## **ADDENDUM NUMBER 2**

**BRADLEY ES & MARSHALL ES**  
**CANOPY REPLACEMENT**  
**Bid No. F13-07**

***SAN BERNARDINO CITY UNIFIED SCHOOL DISTRICT***

April 11, 2014

4

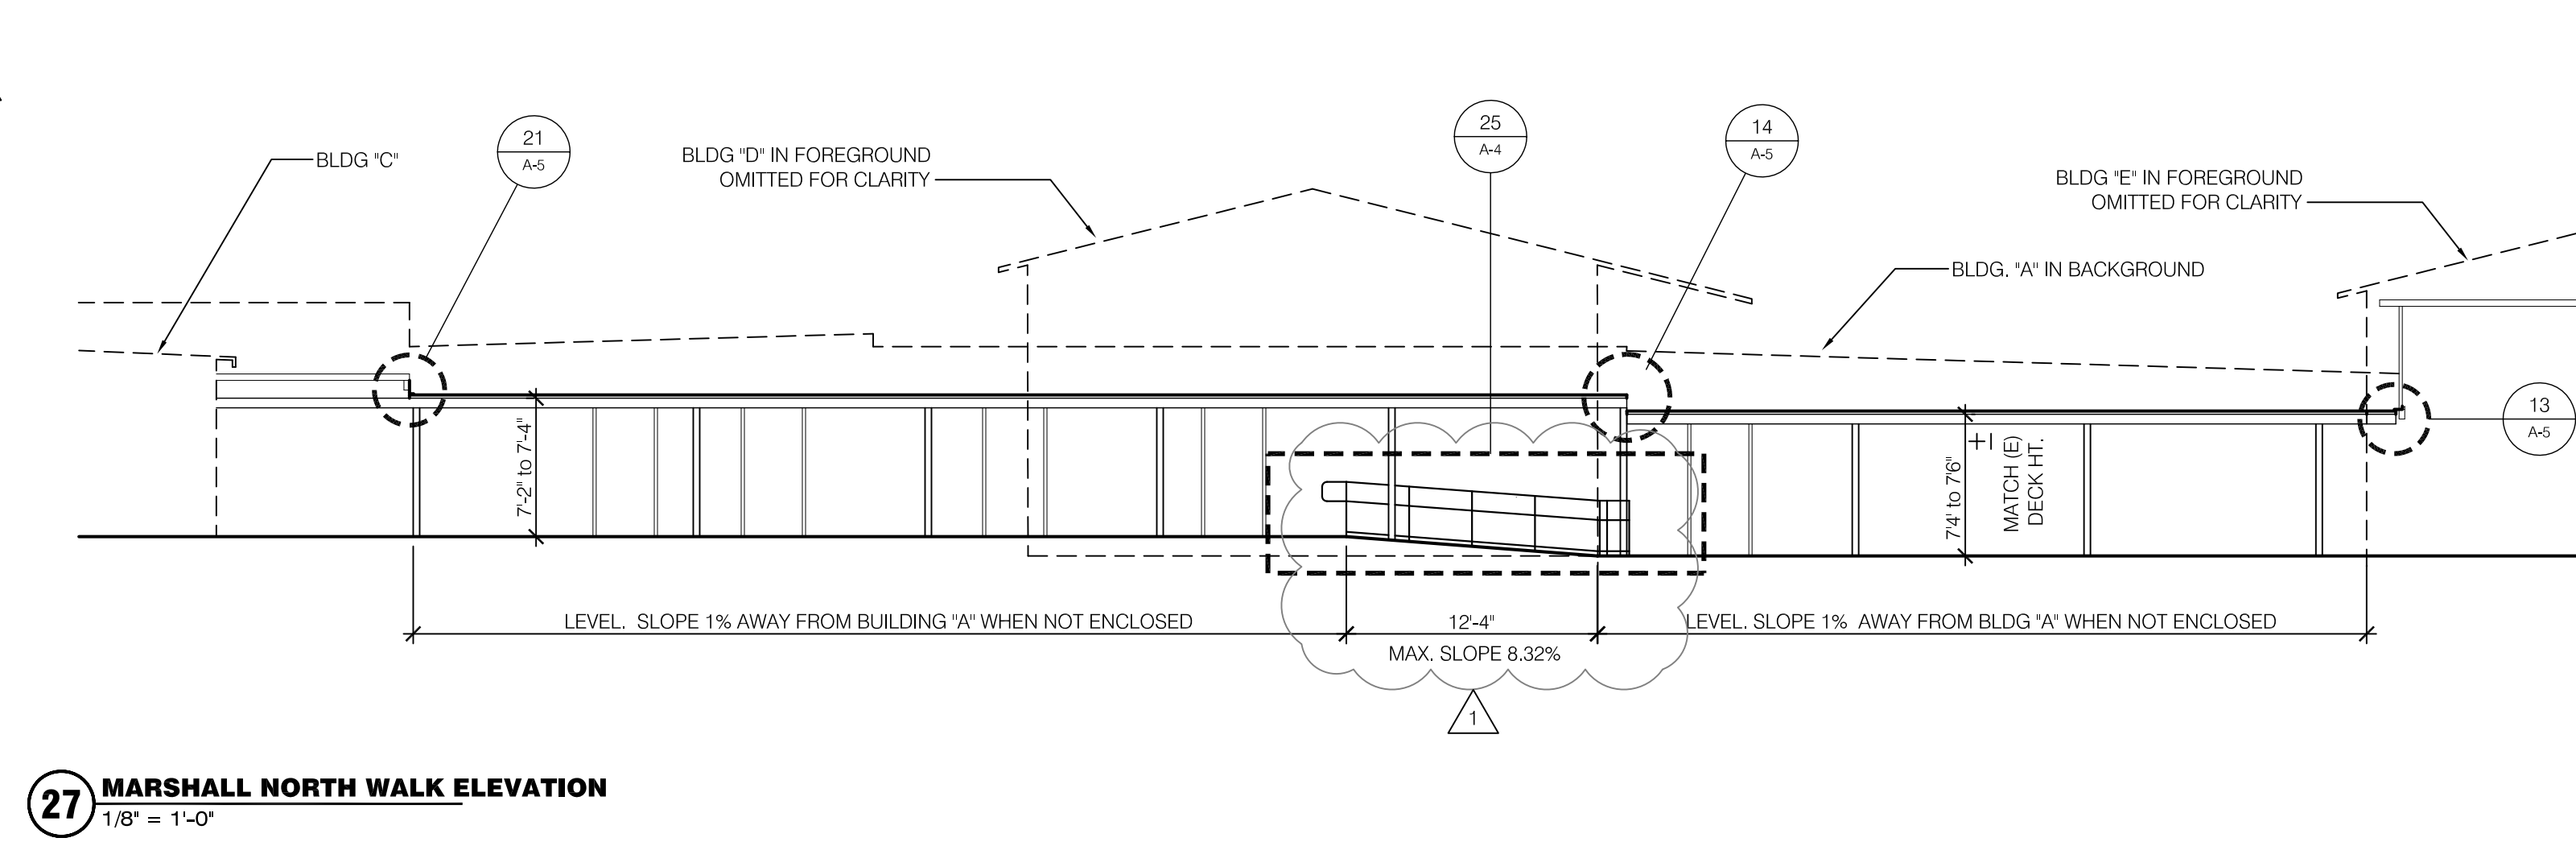
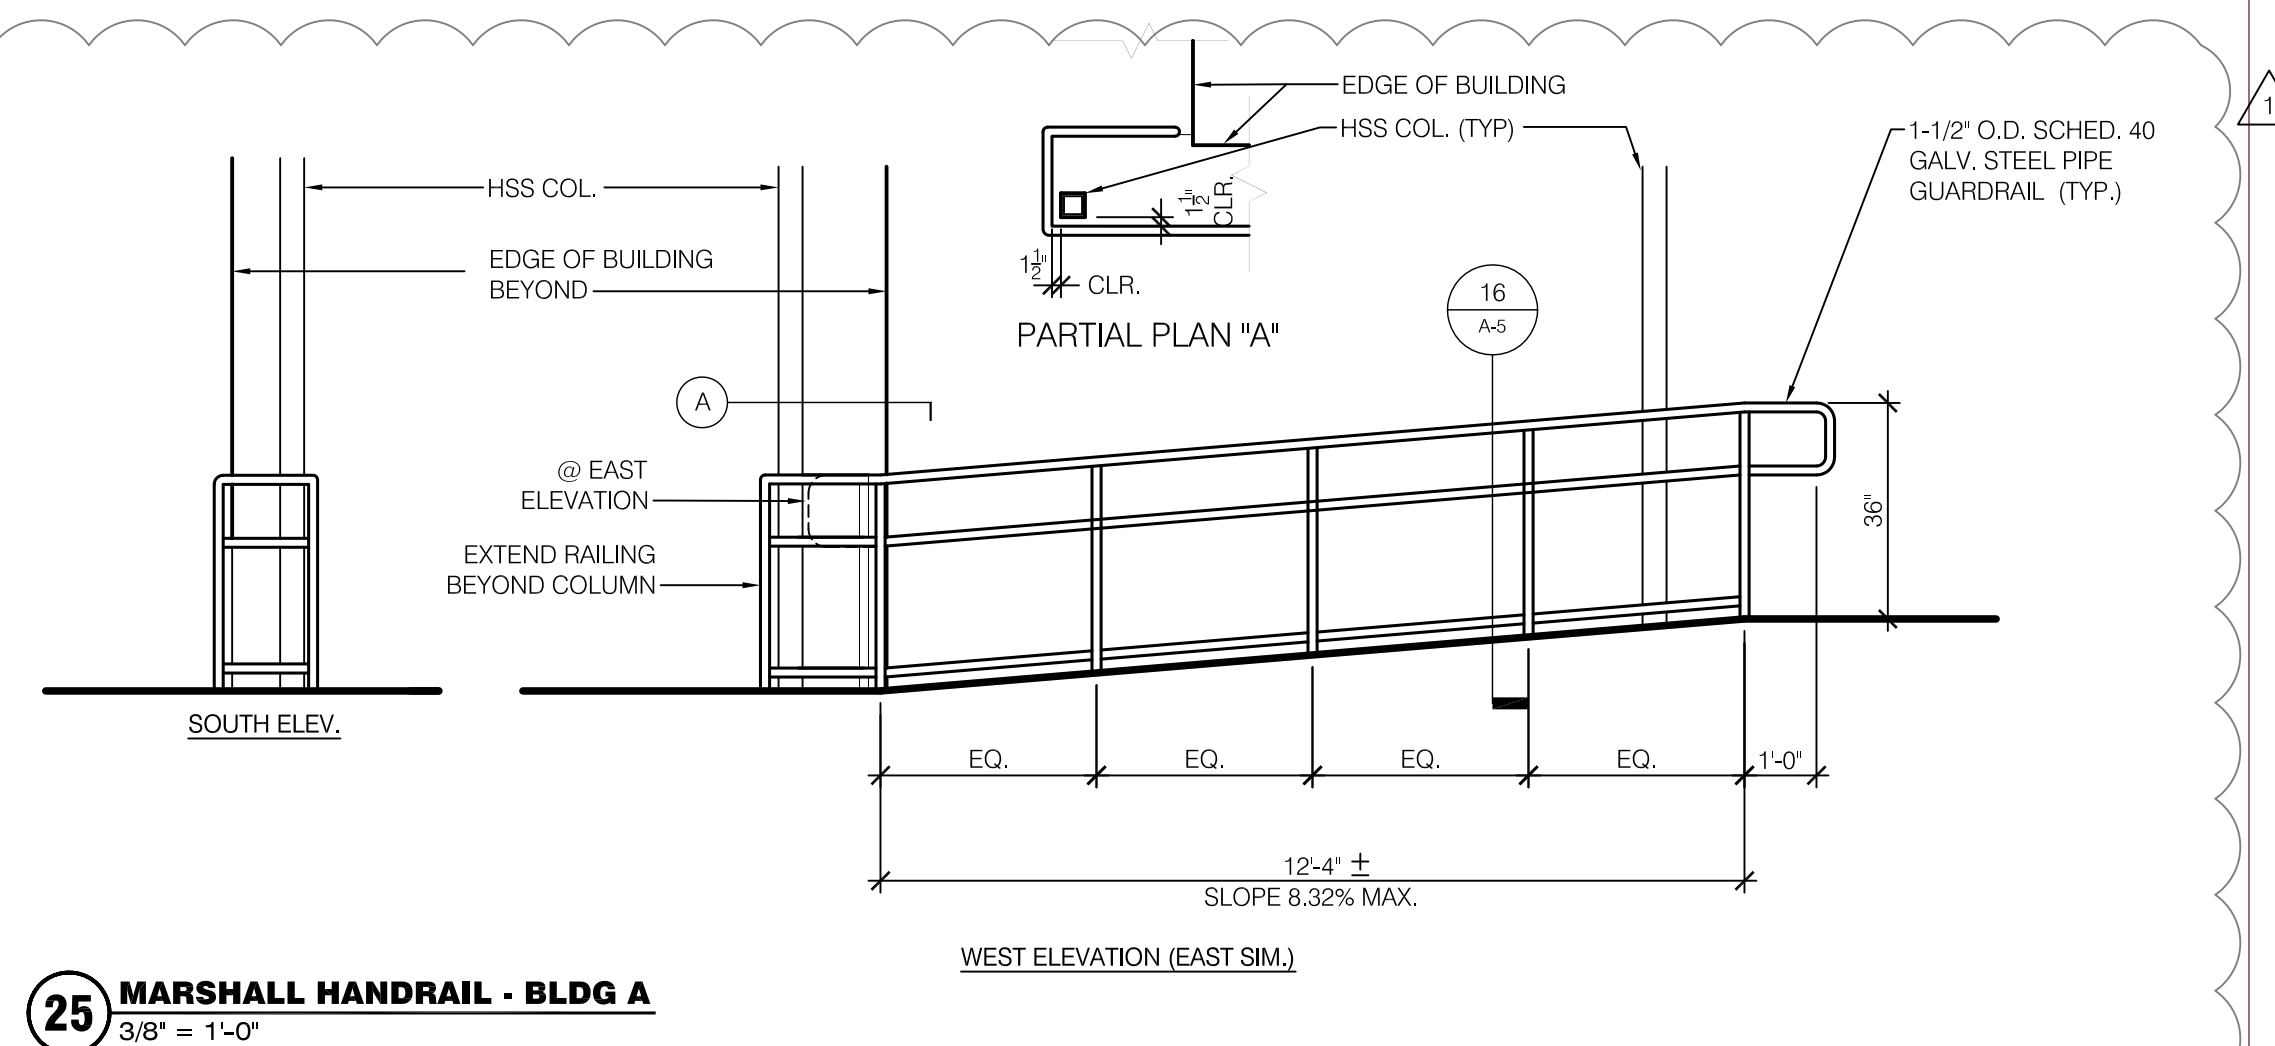
**Item Number 5;** Reference Marshall Sheet A-4 – Marshall Covered Walk @ Bldg 'A' Demo & New Work; Replace this sheet with attached sheet **A-4 – Marshall Covered Walk @ Bldg 'A' Demo & New Work**

Note: Changes are identified by Delta 1 symbol
